## Change Order

Project:  
20-15092 WILCO ANNEX - GC  
151 WILCO WAY  
GEORGETOWN, TX

Change Order: 15

The Contract is changed as follows:  
Misc Subcontractor Change Orders

RE: Williamson Co. Annex  
Shade J-Box locations

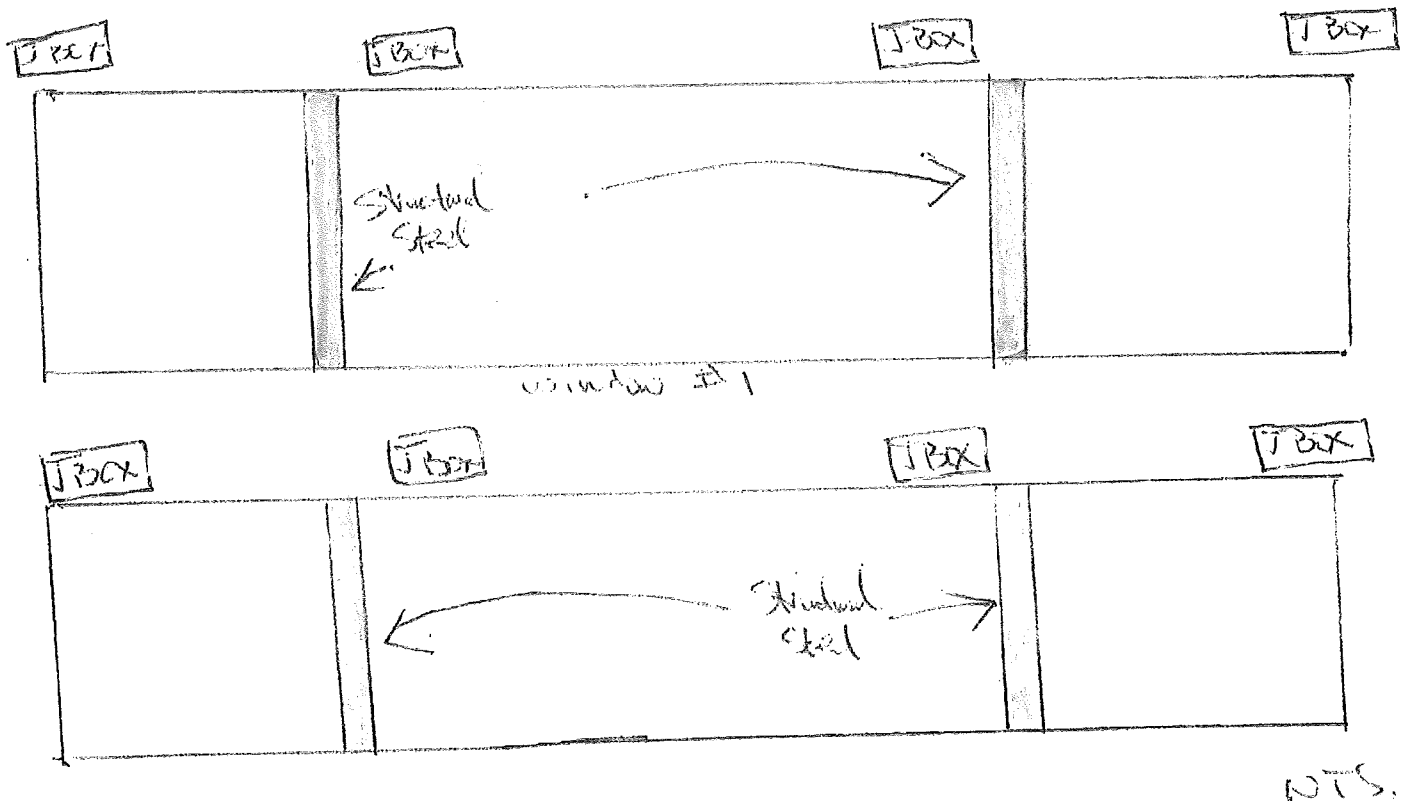
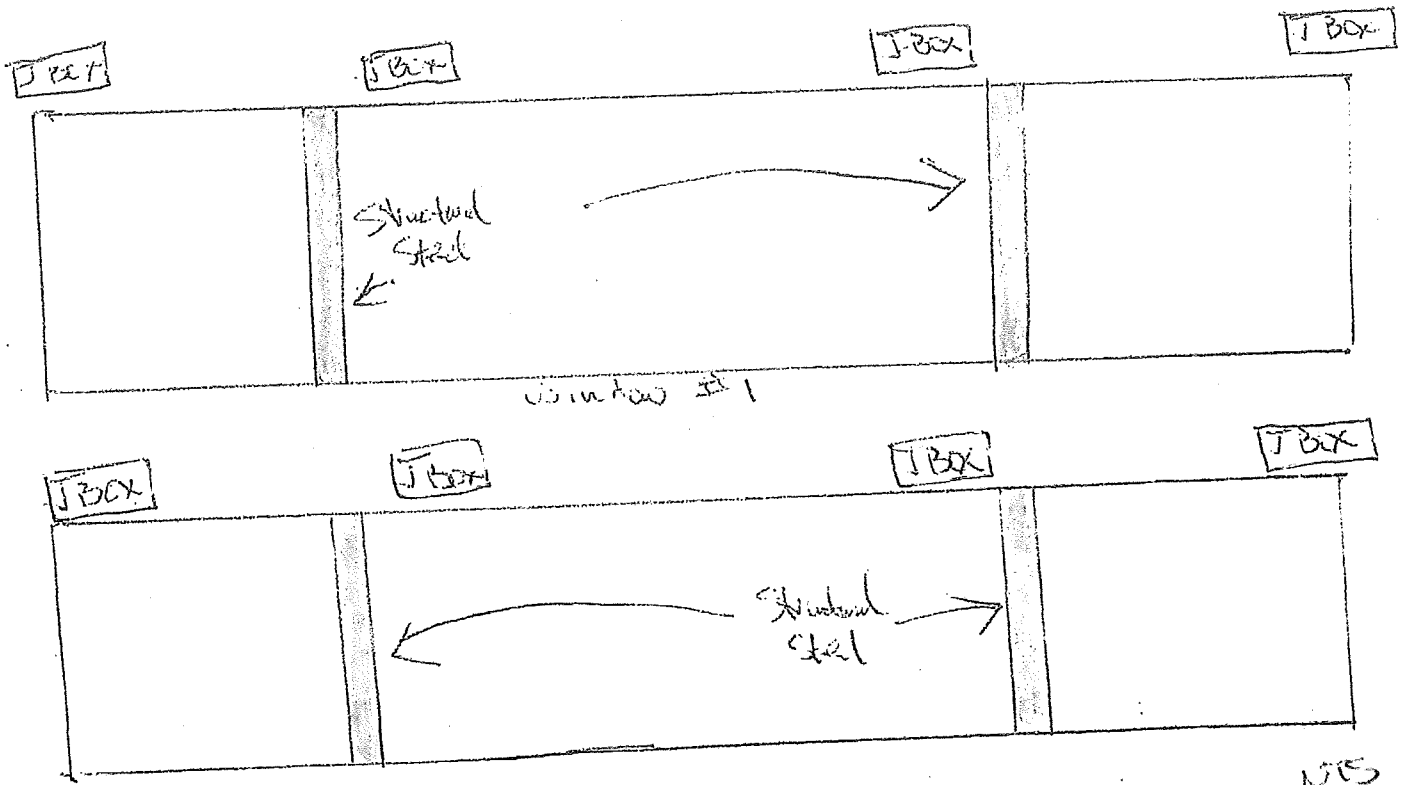
Here is our sketches for the J-Box locations for the motorized shades. Per your directive, we are showing each room.

There are a total of 4 J-Boxes per run of windows (2 runs per room) = 8 ea J-Boxes total per room.

The J-Boxes need to be within 5-8' of motor locations.

- 1- JBox on each end of cladding ribbon window  
(2 total per run)
  - 1- JBox to the left of structural steel
  - 1- JBox to the right of " "
- per window run x 2 windows  
(2 total per run)

2 SECOND FLOOR REFLECTED CEILING PLAN - ALTERNATE ONE-B  
3/8" = 1'-0"

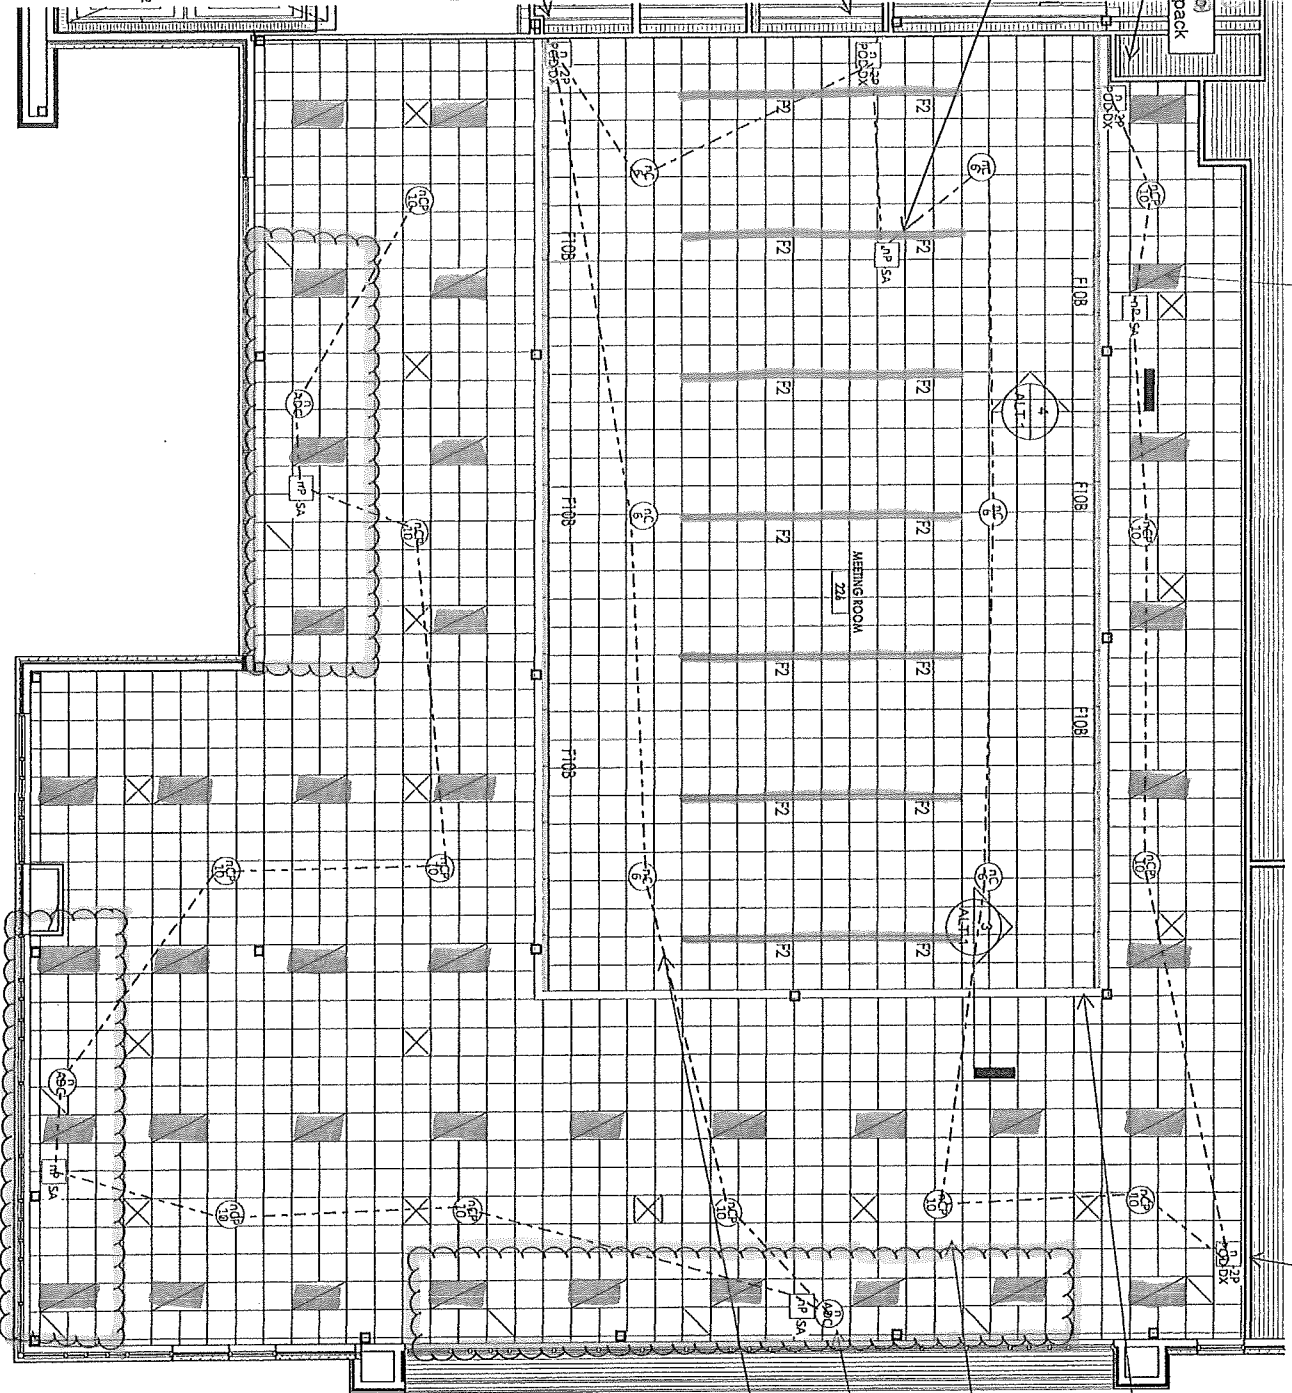
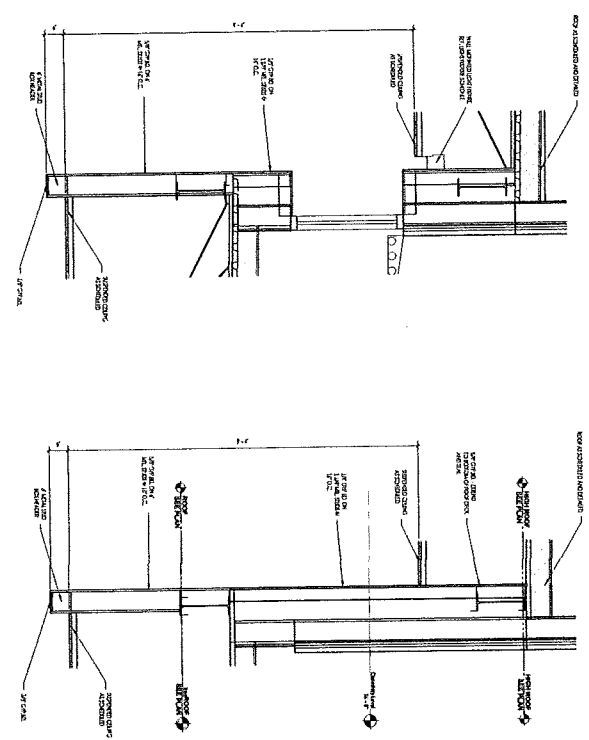
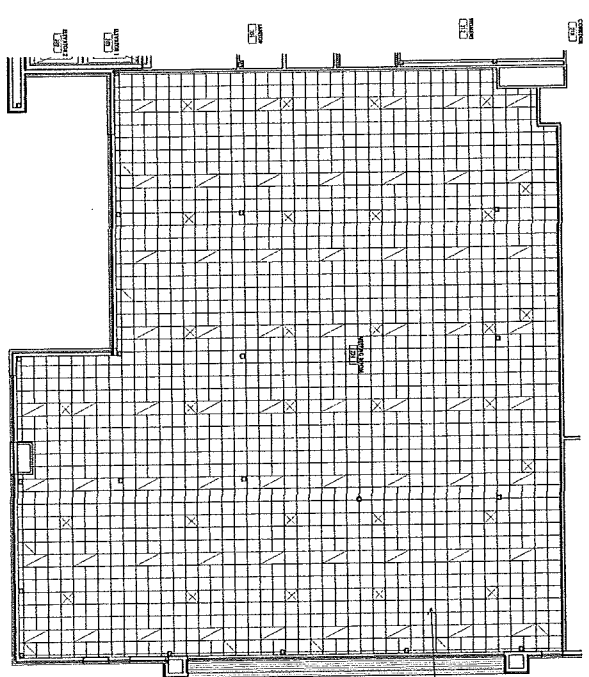
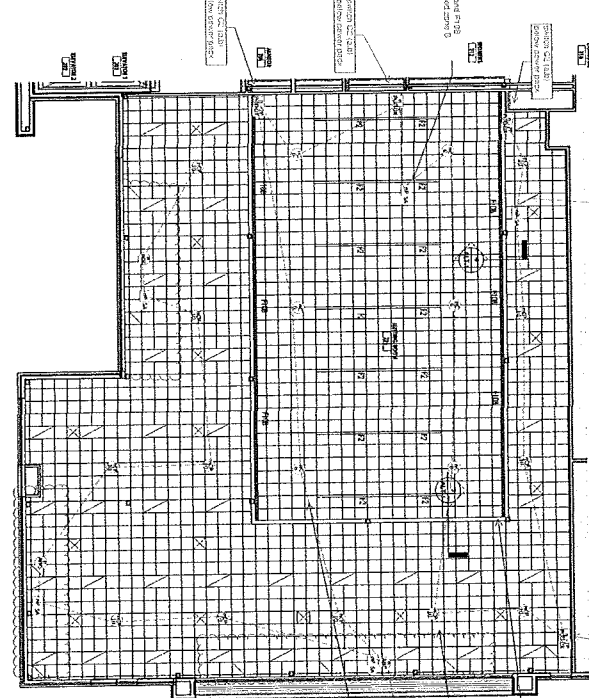
1 We would like to verify the lighting controls for meeting rm 226.

1. Will the F2 and F10B fixtures in the hard ceiling be controlled together on zone B?
2. Will all 2x4's be controlled on Zone A?
3. Please verify switch locations are correct?

1  
Reference attached sketch for zoning and lighting control requirements.

all 2x4's assumed zone A

F2 and F10B  
unmed zone B

daylight zone power  
pack and sensor for  
zone a typ. of 3 areas
